From: [REDACTED]
Sent: Sat, 5 Jul 2025 05:32:43 +0000
To: [REDACTED]
Cc: [REDACTED]
Subject: Re: CGG Regia MSS EP - Not reasonably satisfied - Opportunity to modify and resubmit #2 [SEC=OFFICIAL]
Attachments: OMR #2 - Meeting Prep for 9 July 2025 - Sent to NOPSEMA.pdf

NOPSEMA Meeting Prep

OMR #2 – Regia MSS EP

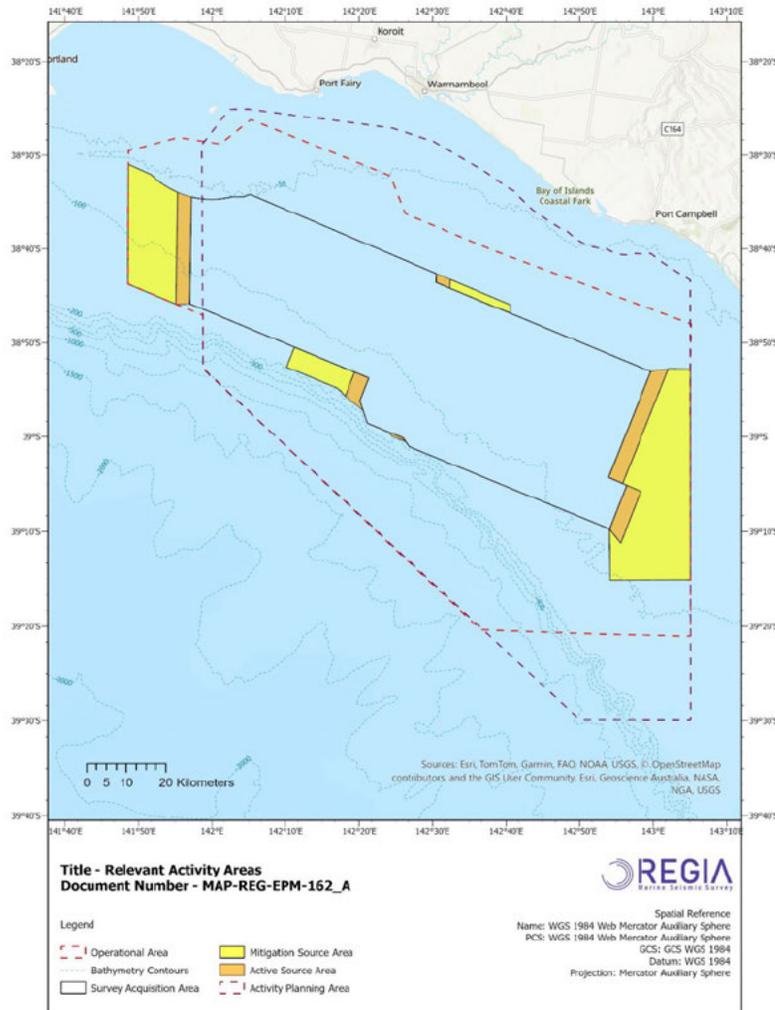
Issue: The EP should include a suitable description of the activity and how it may affect the environment, including the scope and bounds of the activity (GL1721: Section 6.3). The Activity Description in Appendix A2 provides definitions of the Operational Area (OA), Active Source Area (ASA), Survey Acquisition Area (SAA), and a newly defined Mitigation Source Area (MSA). **However, the description of activities in Appendix A2 create uncertainty about where the sound source will be operated.**

Based on NOPSEMA feedback, CGG instituted a new Mitigation Source Area (MSA) defined as: **an area at the end and beginning of the sail lines where a very small source (~ 70 cu in) will be discharged during line changes to alert marine fauna to the presence of the activity.** The definition above and map in figure A2-2 clearly shows areas of the Mitigation Source Area, without any doubt.

1. Given the clarity in the definition provided how can NOPSEMA justify a finding that there is “uncertainty about where the sound source will be operated”?
2. Will these seven words provide the information necessary to close NOPSEMA’s uncertainty gap.

Minor edit to A2: s3.2.1

If the survey vessel leaves the Active Source Area the sound source must not be activated, tested, or in any way discharged at full power. When any contracted vessel is outside the Operational Area, they are subject to all maritime laws but not the OPGGS Act and Environment Regulations.

Minor edit to A2: s3.4

- **Operational Area (OA):** an area in which survey vessel activities can occur including equipment maintenance and deployment/recovery, crew change and resupply. The sound source cannot be active in the Operational Area, outside of the Active Source Area and Mitigation Source Area.

Figure 1: One-third octave band source level for a 2820 in³ seismic array

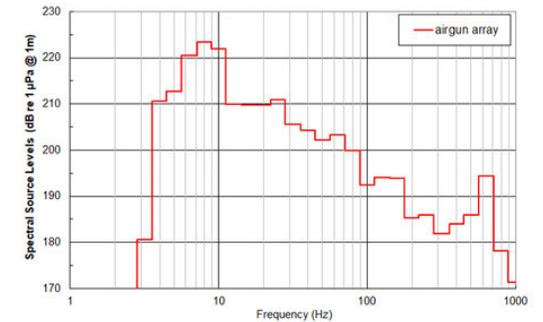
REASONS: CGG has not adequately considered the NMFS (2024) technical guidance updates and, therefore, the EP does not demonstrate with sufficient confidence for NOPSEMA to be reasonably satisfied, that impacts and risks to protected matters will be managed to acceptable levels. The EP has not accounted for updates to marine mammal weighting functions and, therefore, overlooks the most relevant metric for the assessment of TTS in low-frequency cetaceans (SEL_{24h}), including blue whales and southern right whales. The EP's impact assessment and control measures (e.g. shut down zones) for blue whales and southern right whales are also based on animal modelling predictions for TTS. As advised (12 March 2025), it is unclear to NOPSEMA whether an analysis of propagation differences between NMFS (2018) and NMFS (2024) can be reliably applied to the animal model results.

This matter was raised previously by NOPSEMA and was directly addressed by conducting further analysis (SLR Report 2025, Appendix B7c). To be clear though, NOPSEMA concern is about the accuracy of the prediction of impacts at the extremity of the TTS range (14.2 km) where the modelling predicted a 1% probability of exposure.

Notwithstanding, hearing groups where thresholds changed were re-modelled using the NMFS S 2024 User Spreadsheet Tool, which included a Weighting Factor Adjustment (WFA) assessment. This is a recommendation by NMFS. The LF TTS (SEL_{24h}) threshold did not change and was not included in this assessment.

1. How did NOPSEMA consider the commitment to further sound propagation modelling in s5.2.5 of Appendix B3 in not being reasonably satisfied?
2. Can NOPSEMA please explain what deficiency there is that:
 - a) was not adequately covered by the SLR work which was specifically focused on updating our predictions of impacts to conform with NMFS 2024.
 - b) What evidence does NOPSEMA have to show that:
 - i. If the SLR report is insufficient, that the Regia MSS EP has underestimated impact?
 - ii. Any remaining deficiency would lead to unacceptable impacts on LF cetaceans?
